ADDENDUM NO. 1

Sewer Project 2011-S-1A, Lift Station No. 7 Improvements
Grand Island, Nebraska
OA Project # 011-2347

3. Refer to the Plans, Sheet 5 of 26 - Site Plan – Piping Plan

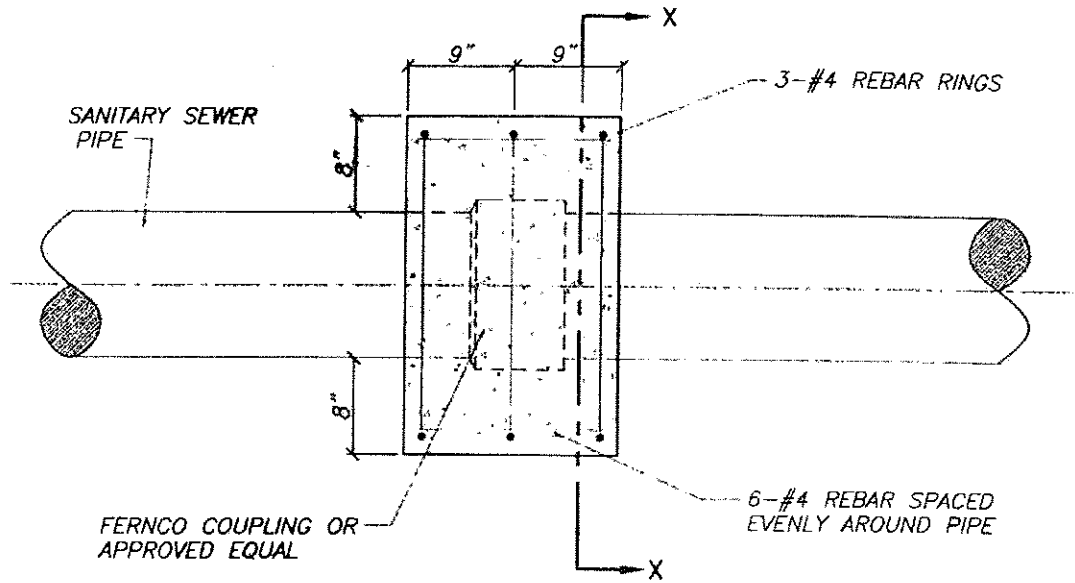
Revise the note to read:
Proposed 6” By-Pass Pumping Piping

Add the following note to the Sheet:

The Contractor is responsible for installing the 4” electrical conduits (with pull strings) shown. The City of Grand Island Utilities Department is responsible for installing the primary conductors in the conduits. The Contractor is responsible for coordinating the location and installation with the City of Grand Island Utilities Department. Refer to sheets 19-22 for additional details.

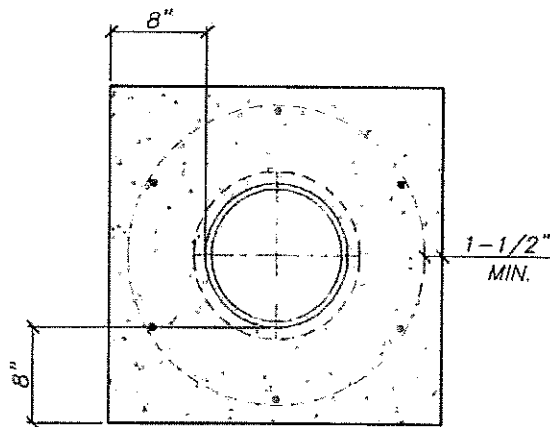
Add the attached Plan 133 – Joint Encasement to the Standard Plan Drawings.
